Chapter 13 Material Project Changes since the 2003 EIA

13.2 SUMMARY OF MATERIAL PROJECT CHANGES

Figure 13.1 Recorded sites of protected bird species during nesting period at Chaivo Bay area in 2005. The stars depict sightings of dunlin. Green dotted line = original Alternative 1 onshore pipeline route; red solid line = re-routed Alternative 1 onshore pipeline route.

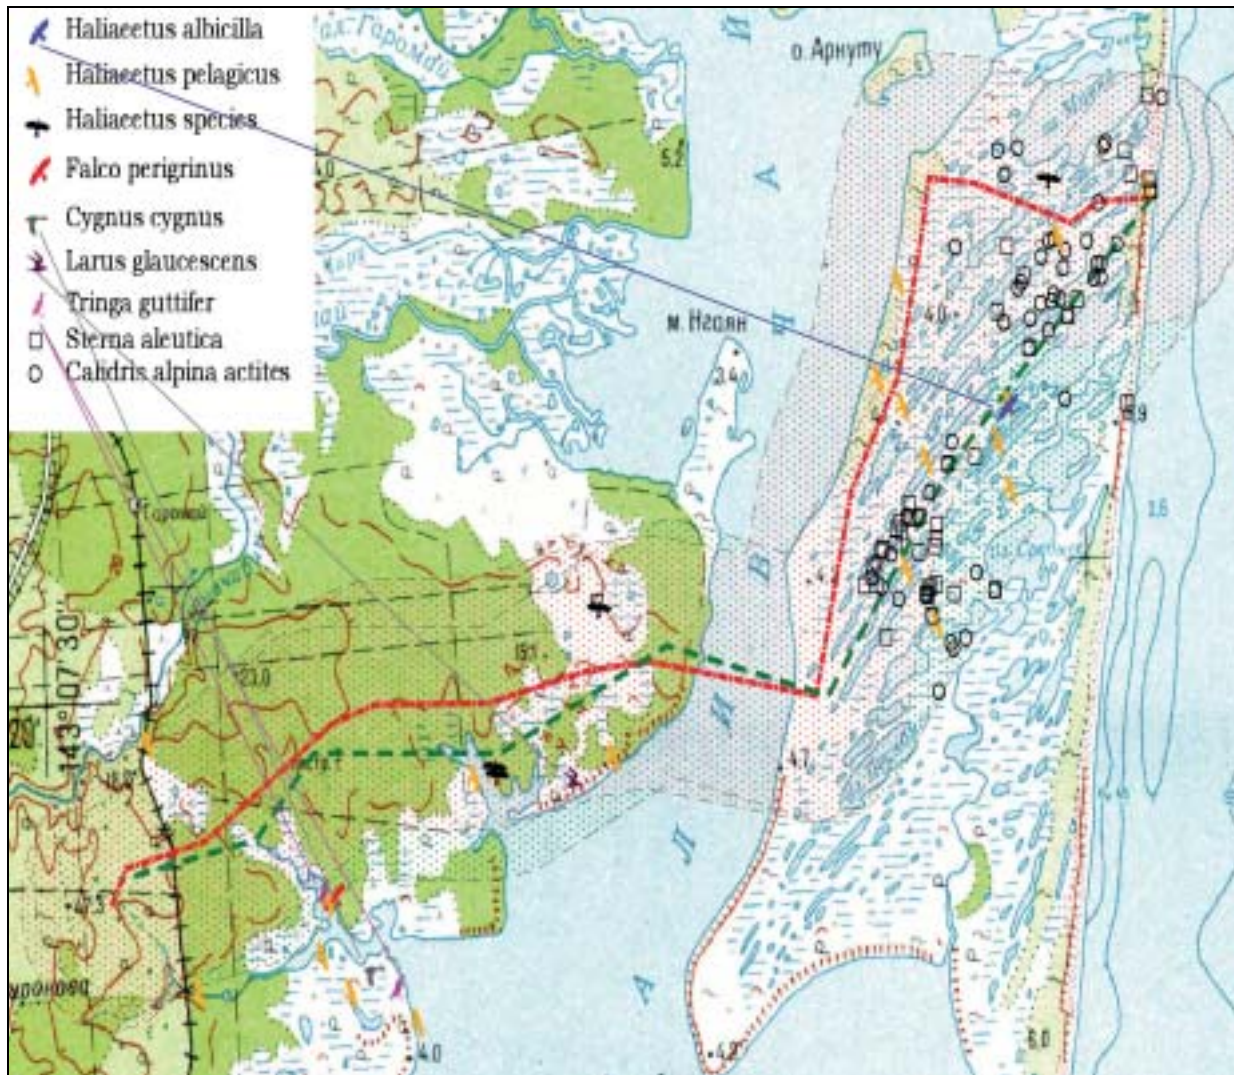
11.	<p>Onshore Pipelines</p> <p>Reroutes associated with the Alternative 1 reroute onshore</p>	<p><i>EIA Volume 2, Chapter 2.3.1</i></p> <p>The project has maintained its pipeline routing philosophy, as set out in the EIA, in terms of avoiding sensitive areas wherever practicable to do so.</p>	<p>In March 2005, the Company made a decision to move the offshore and onshore pipeline route at Piltun in order to avoid a known western gray whale feeding area. This new routing is known as Alternative 1. Given that this has been a significant design change since the EIA (2003), a more detailed account of the decision-making and environmental appraisal process is given in Section 13.3 below.</p> <p>In addition, the recommendations made during combined archaeological, ornithological and technical surveys carried out in June 2005 in the selection of the Alternative 1 pipeline reroute onshore resulted in four route changes to avoid potential impacts to birds and heritage sites:</p> <ol style="list-style-type: none"> 1) Deviation in the section from the landfall to the pig trap site (at kilometre point (KP) 1) in order to avoid crossing the largest lake near the landfall, which provides an important duck nesting habitat; 2) Deviation in section pig trap site to HDD pull in point (between KP 3 & 5), in order to avoid archaeological sites and to avoid larch forest; 3) Deviation northwards (between KP 8.9 and 10.5) in order to be further away from Greenshank habitat and eagle nests, and avoidance of archaeological sites;

Ref	Project Asset	Project design / activity stated in EIA (2003)	Change in design since EIA (2003)
			<p>4) Onshore pipelines and the main facilities layout are to share the RoW to minimise environmental impact and move this northwards to avoid spotted greenshank habitat.</p> <p>5) The footprint of the project has been reduced by decreasing the RoW width and choosing block valve sites and the pig trap sites at strategic locations, such as the sharing of Sakhalin I land at the ENL OPF site for the siting of block valve sites and some of the RoW.</p> <p>The approved route stretches 21.8km. Between May-Aug 2005, the design construction plans were approved by the Ministry of Natural Resources (MNR) (RosPrirodNadzor) and public hearings were undertaken in Nogliki district. The plans were submitted to MNR for ecological expertiza review in late September 2005, and is expected to conclude in December 2005.</p> <p>See Figure 13.1.</p>

Figure 13.2 The three Piltun pipeline route options, offshore and onshore, also showing their location in relation to the WGW inshore feeding area.

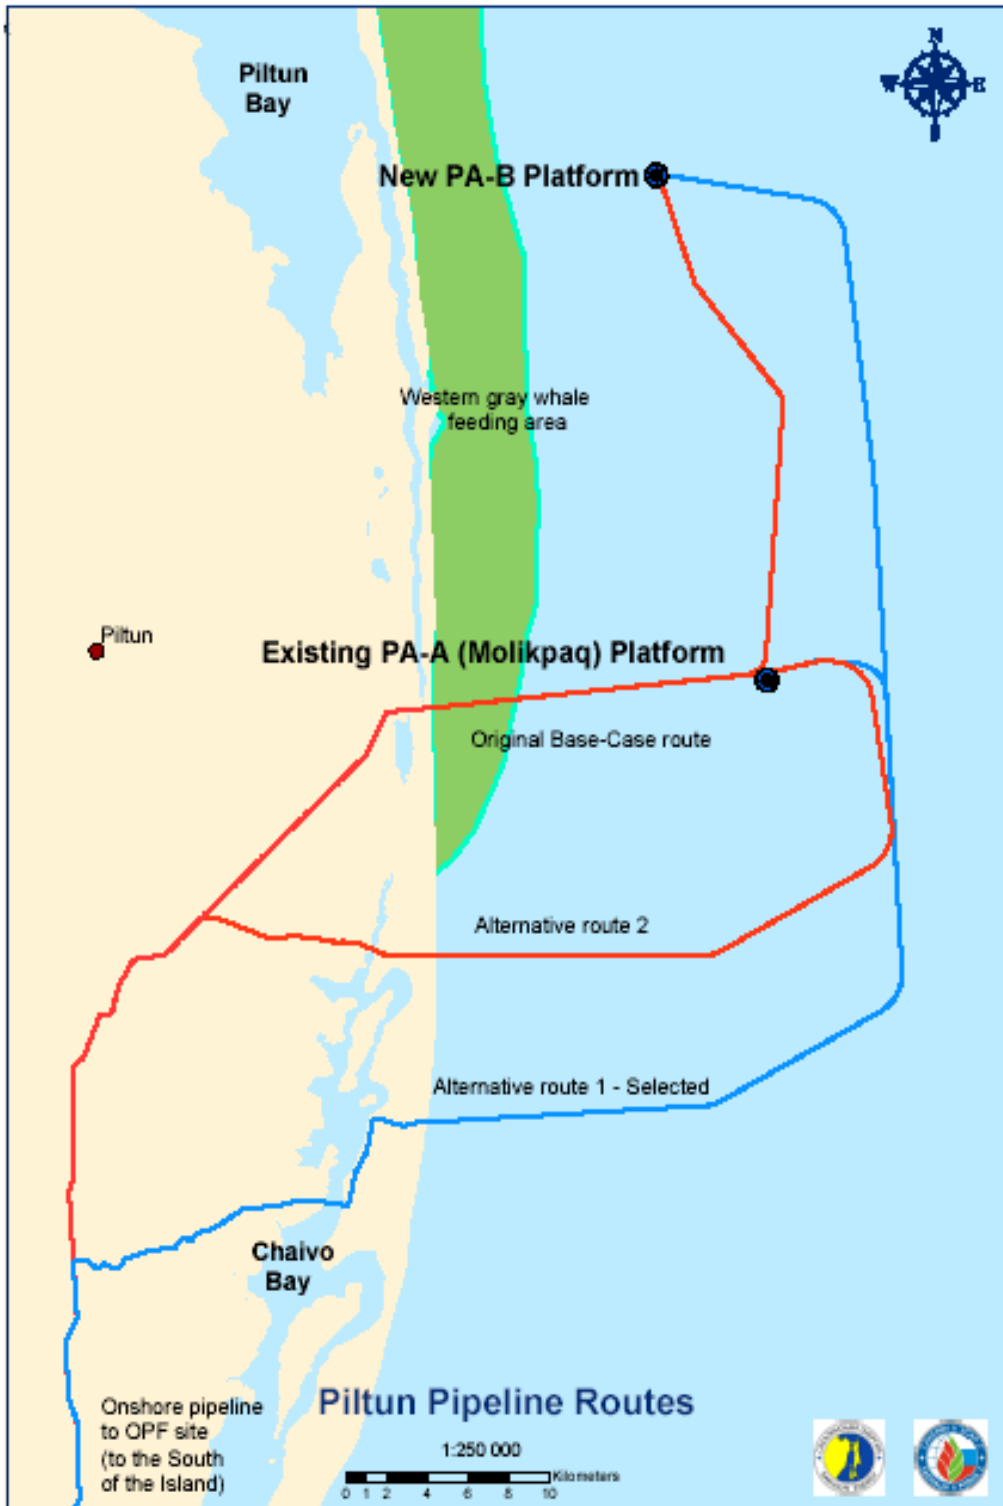
Figure 13.2 shows the original route proposed for the pipeline system (shown as the 'Base Case' on Figure 13.2), as assessed in the Phase 2 EIA, from the PA Field, via the platforms (PA-B and PA-A) to the landfall south of Piltun Bay. The landfall section of the pipeline passes through the southern end of the WGW feeding area at Piltun. This route formed the basis upon which Russian Government approvals were obtained. However, one of the conditions issued by the state environmental expert review, undertaken as part of the approvals' process, stated that additional acoustics studies should be carried out with respect to potential impacts on the WGW population.

Two alternative pipeline routes were investigated through this options analysis. Both run from the PA-B platforms to the east before turning southwards and arriving at a more southerly landing than the Base Case; Alternative 1 comes to shore at approximately 20km south of the Base Case; and Alternative 2 has a shore landing approximately 12 km south of the Base Case. Importantly, both of these alternative routes avoid the nearshore Piltun WGW feeding area as well as the offshore feeding area (see Figure 13.2).

SEIC undertook a review and analysis of the ISRP feedback, comments from other stakeholders, and the Company's more recent noise related modelling and verification work. The Company determined that Alternative 1 or 2 provided a more preferable option in environmental terms with respect to the WGW. A decision to re-route the offshore and onshore pipelines was therefore considered the most appropriate mechanism and way forward for reducing the risk of harm to the WGW population from project activities.

As part of the process for determining which was the better of the two options from an overall environmental perspective, additional survey work was carried out to assess onshore impacts. This took into account, amongst others, the needs of the indigenous reindeer herders in terms of pasture conservation and calving grounds, and Class 1 forest areas. Although Alternative 1 passes through or adjacent to some seasonally sensitive lagoon environments, appropriate mitigation measures for managing potential onshore impacts are available, and on this basis SEIC publicly announced its decision in March 2005 to progress with Alternative 1 as the preferred reroute option.
